# 1971 Corvette: Service Bulletin: Anti-Diesel Relay

**Subject:** Anti-Diesel Relay

**Bulletin No:** 71-T-44

**Date:** Aug. 5, 1971

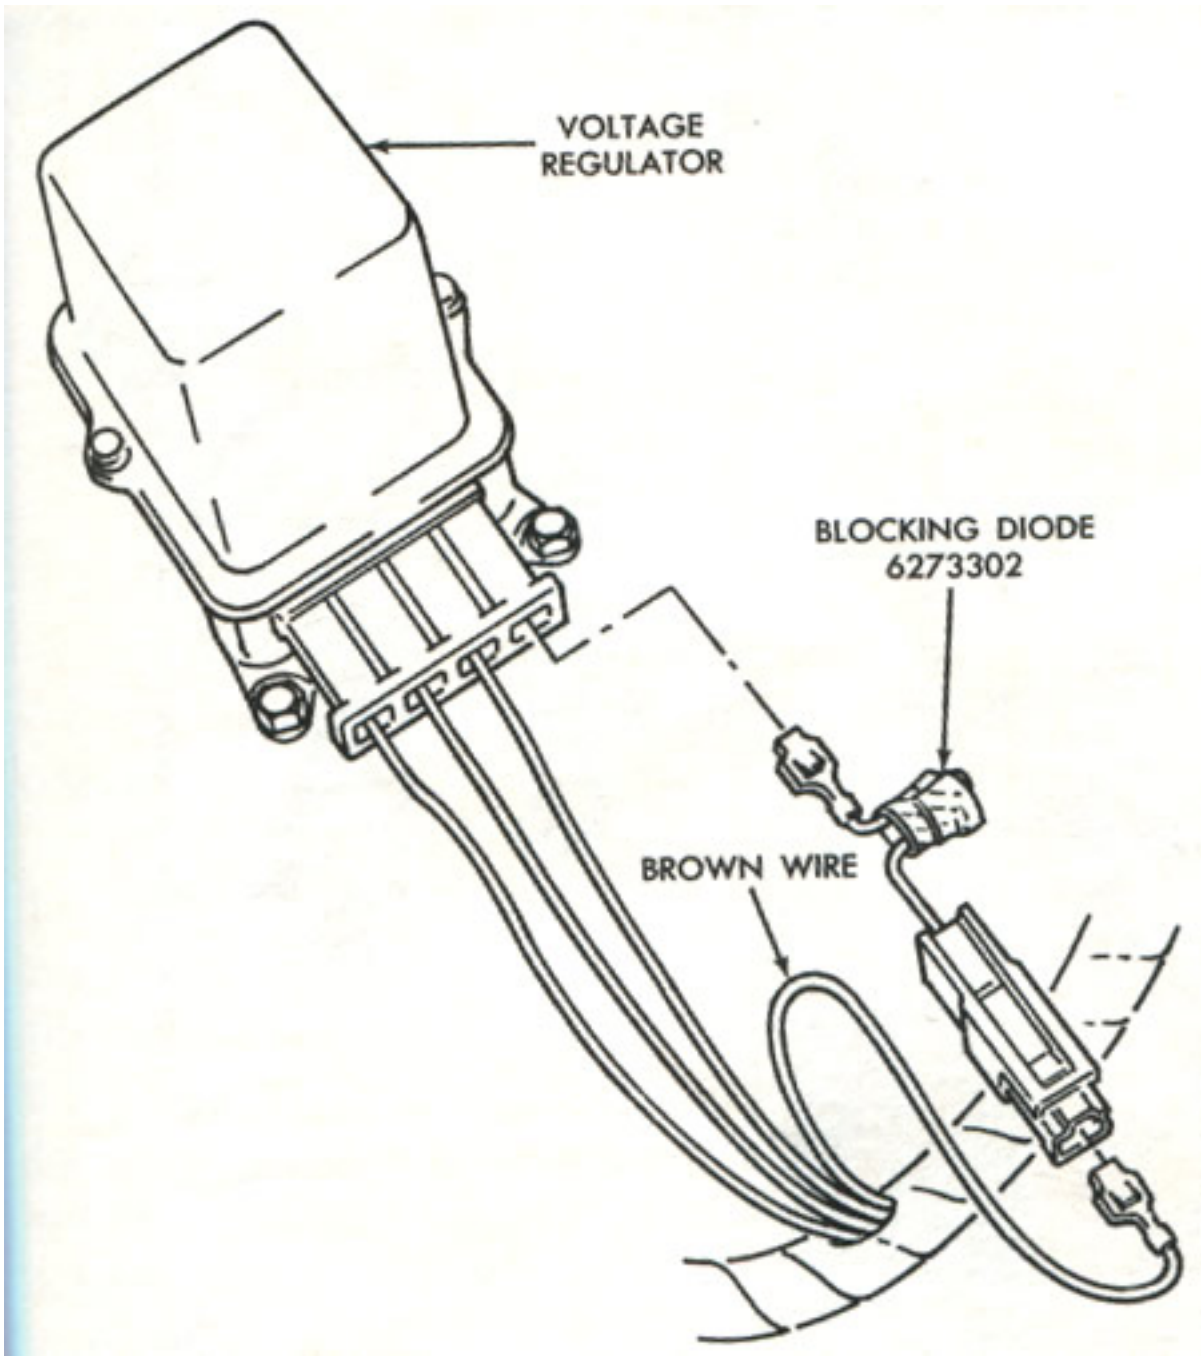
Delcotron feedback at the anti-diesel relay can result in a shorted transistor in the timing circuit of the relay. A shorted transistor will cause the anti-diesel relay to hold the air conditioning compressor clutch engaged continuously, after the engine is turned off, draining the battery.

For service on light trucks, to prevent Delcotron feedback to the anti-diesel relay, blocking diode, Part Number 6273302, should be installed at the voltage regulator as outlined under Service Procedure - Truck.

Blocking Diode Installation

1. Disconnect wiring harness from voltage regulator.
2. Remove brown wire from the plastic connector.
3. Install the blocking diode between the voltage regulator connector and the brown wire as illustrated in Figure 1.
4. Connect harness to voltage regulator.
